REQUEST FOR INFORMATION DATE: December 20, 2016 NO.: RFI-388

Project Name: 15051-Webster University Interdisciplinary Science Building Project No.: 15051

Subject: Exterior Housekeeping Pads at East Side of Site

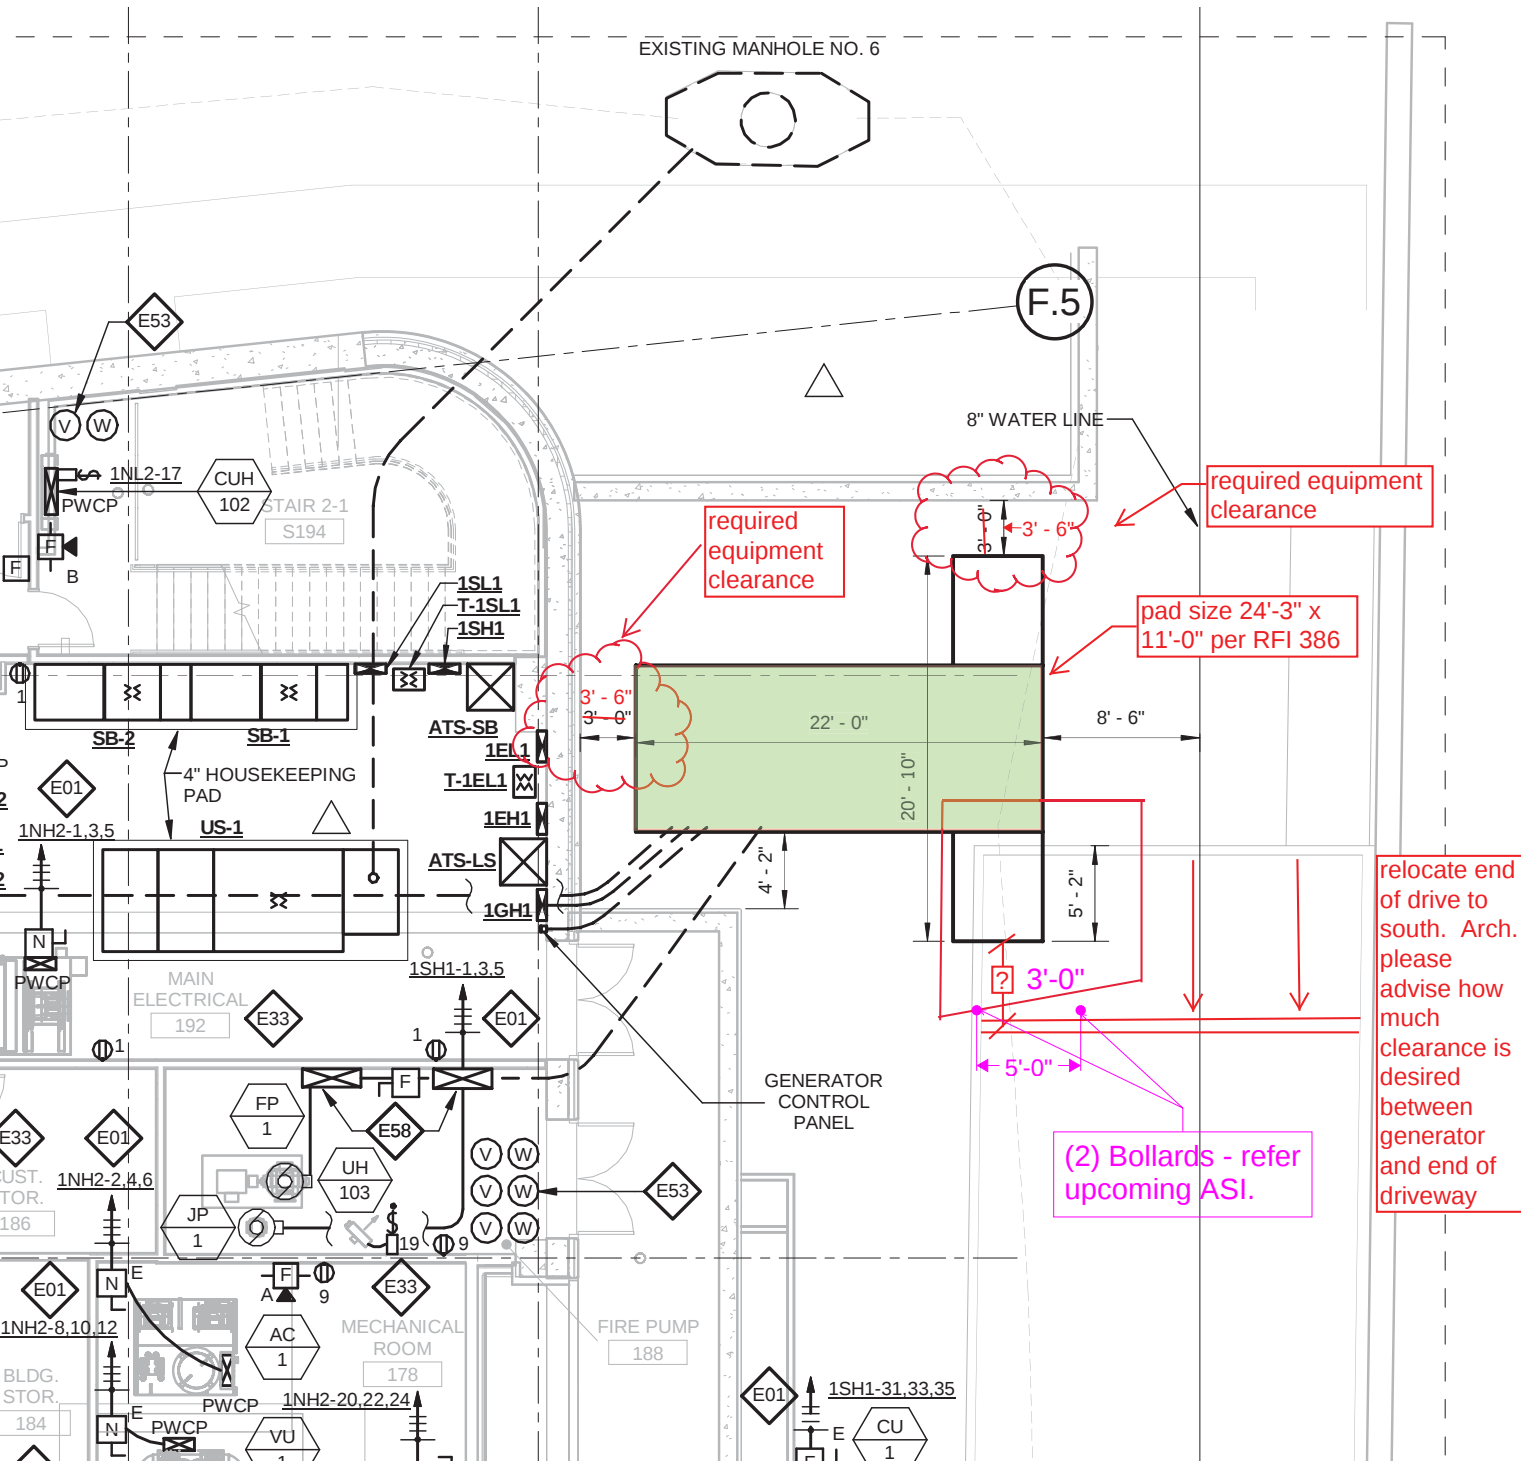
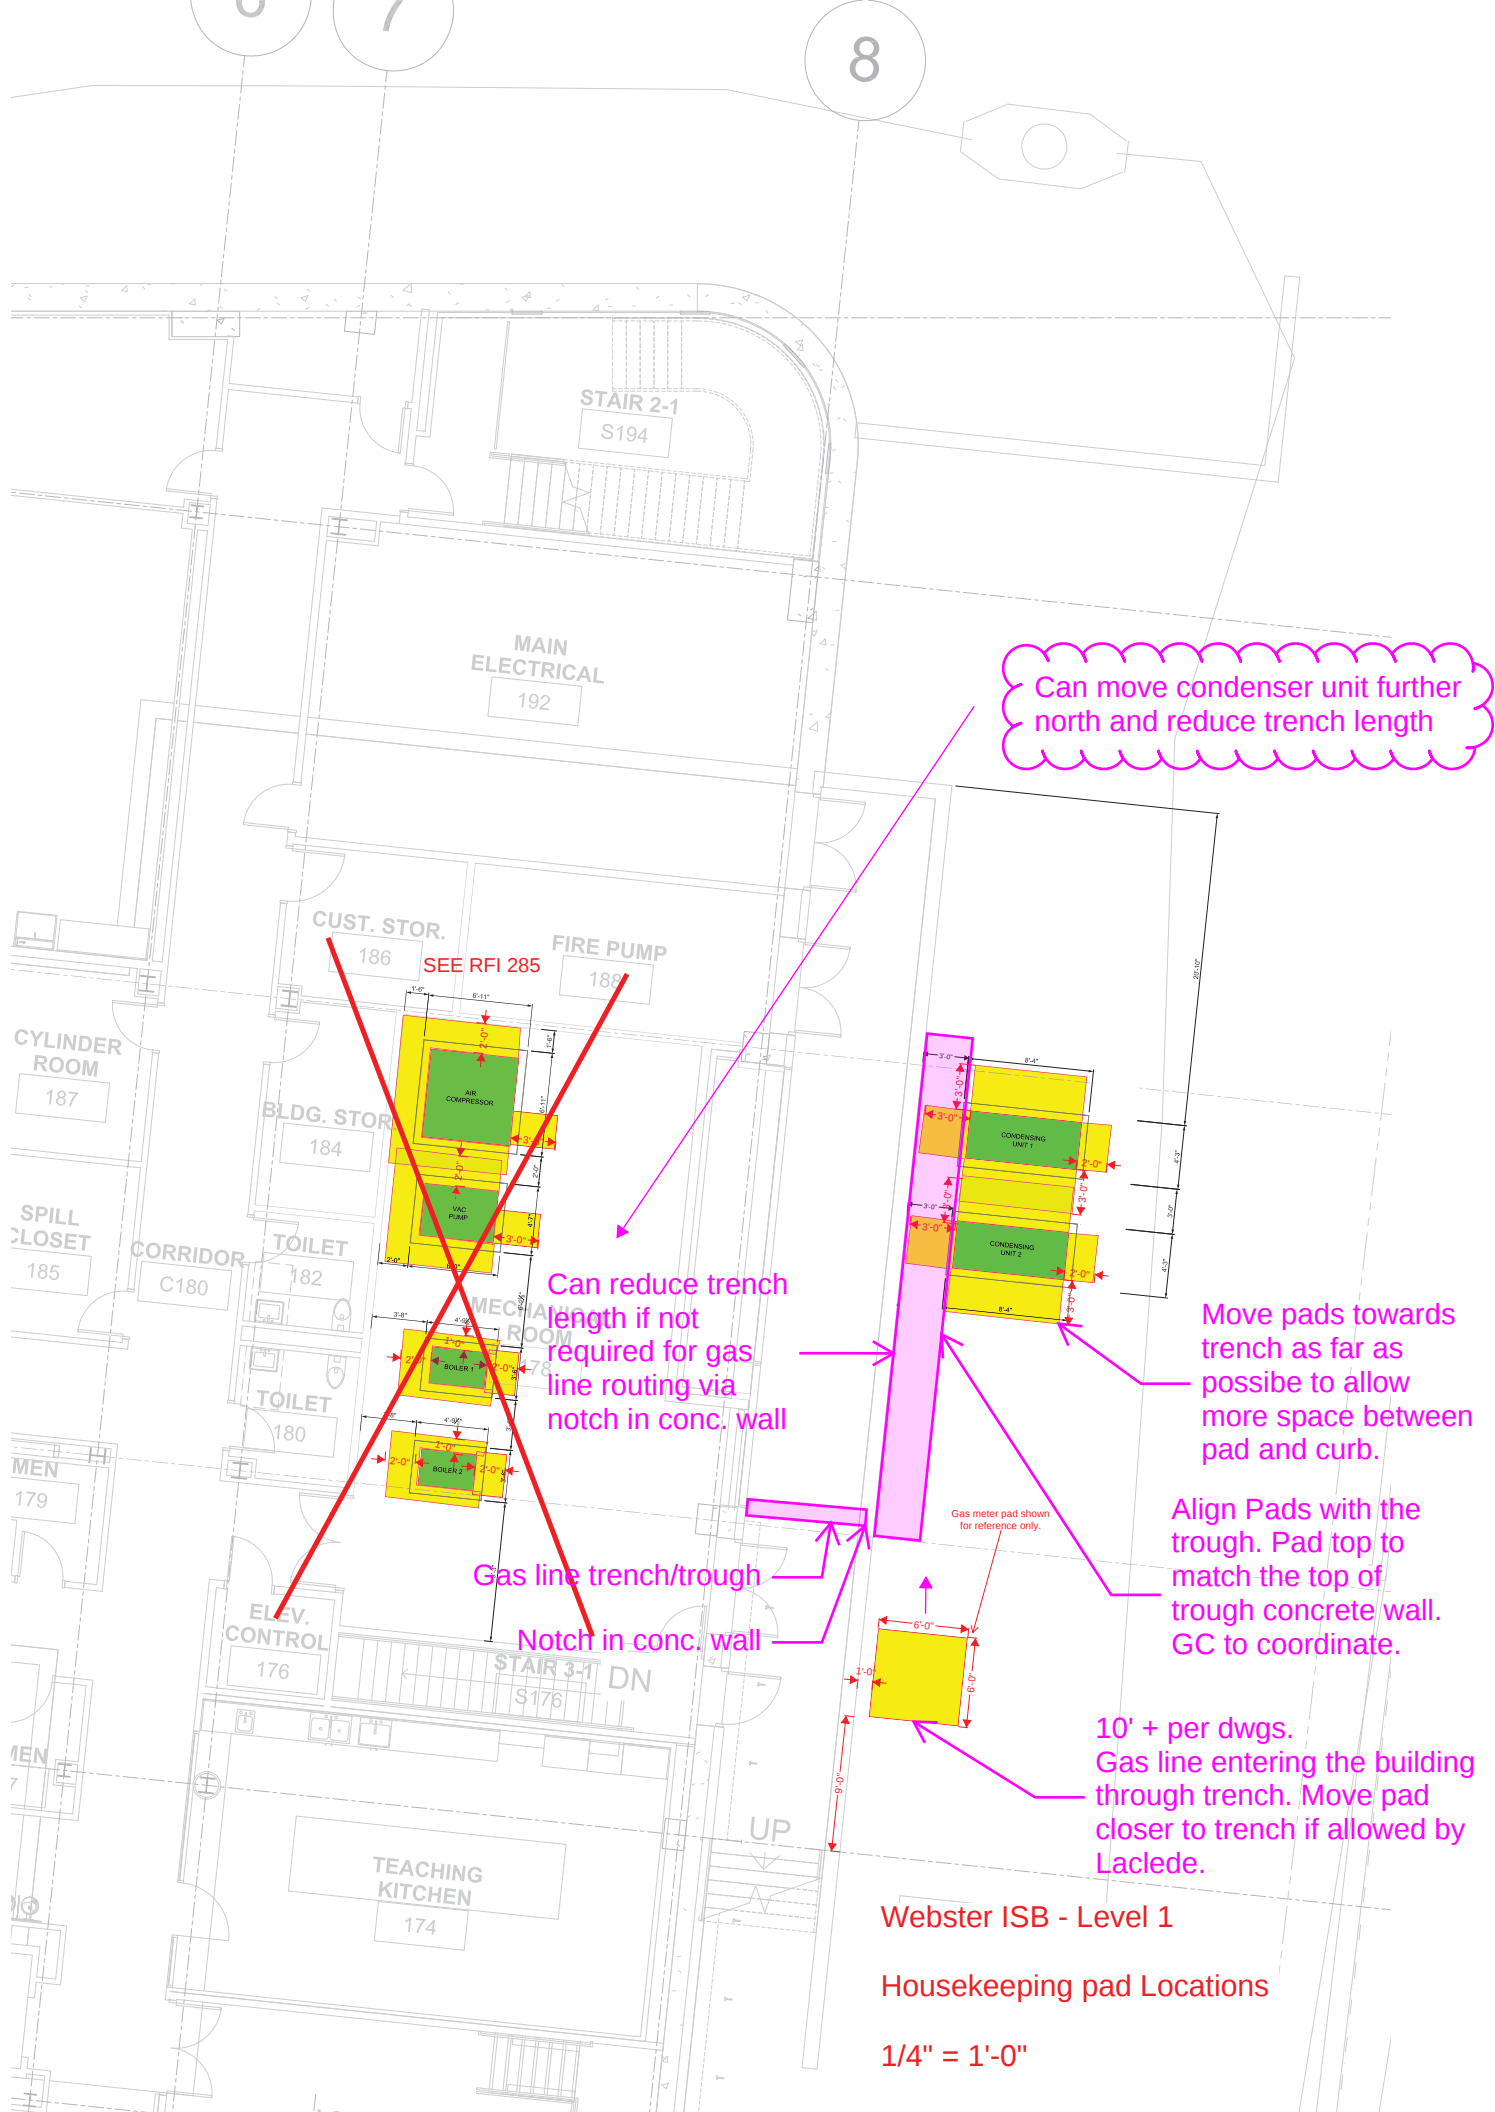
1. Please see attached size and location of proposed housekeeping pads. Please confirm their location is acceptable.
2. Please confirm how much clearance is desired between the generator and relocated end of driveway.

4. Please confirm the desired top elevation of the pads relative to the surrounding grade (i.e. top of pad flush with grade at high side, top of pad 4" above grade at high side, etc.).

2. We recommend two bollards be placed a minimum in order to ensure a vehicle does not accidentally jump the curb and hit the generator enclosure.
4. Top elevation of pads to match the top elevation of the trench wall per discussion with Owner, Architect, and Contractor during OAC meeting on 1/10/17. Coordinate top elevation of equipment pads by others Architect, Civil Engineer, Structural Engineer, equipment manufacturer, and all other trades, and verify top of slab shall remain above any drainage requirements of the grade.

Sketch for condensing units. 2017.01.12 Jill Walker/DMA

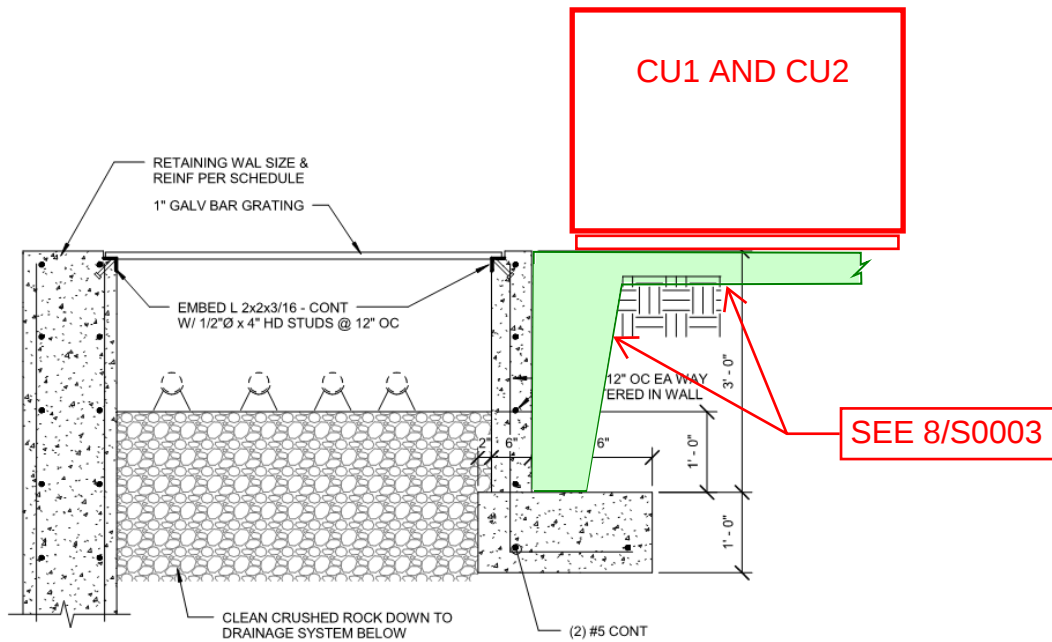
3. Please confirm the thickness and reinforcement requirements for the pads for Condensing Unit 1, Condensing Unit 2, and the Gas meter. The generator thickness and reinforcement requirements were answered in RFI#386.
See attached sketch for condensing units. 2017.01.12 Jill Walker/DMA

1. Per discussion with the Owner, Architect, and Contractor at OAC meeting on 1/10/17, increase the service clearance at each condensing unit to accommodate for future maintenance/replacement of unit that may be of different size. Therefore, provide service clearance requirements of the basis of design condensing unit model, which are greater than the service clearance requirements of the submitted units. These clearances are as follows:

Response: Minimum clearance of each condensing unit shall be 36" from walls, shrubbery, privacy screening, etc.
Minimum clearance between adjacent condensing units shall be 72".
Minimum service clearance shall be 48".
Top discharge area shall be unrestricted for 100" minimum. Unit shall be placed so roof run-off water does not pour directly on unit.
Pad dimensions shall extend at least a minimum of 4" beyond the equipment footprint dimensions.
The Contractor shall coordinate the final locations with the Architect, Civil Engineer, Structural Engineer, equipment manufacturer, and all other trades. Refer to specification section 230500-3.5 for additional requirements.
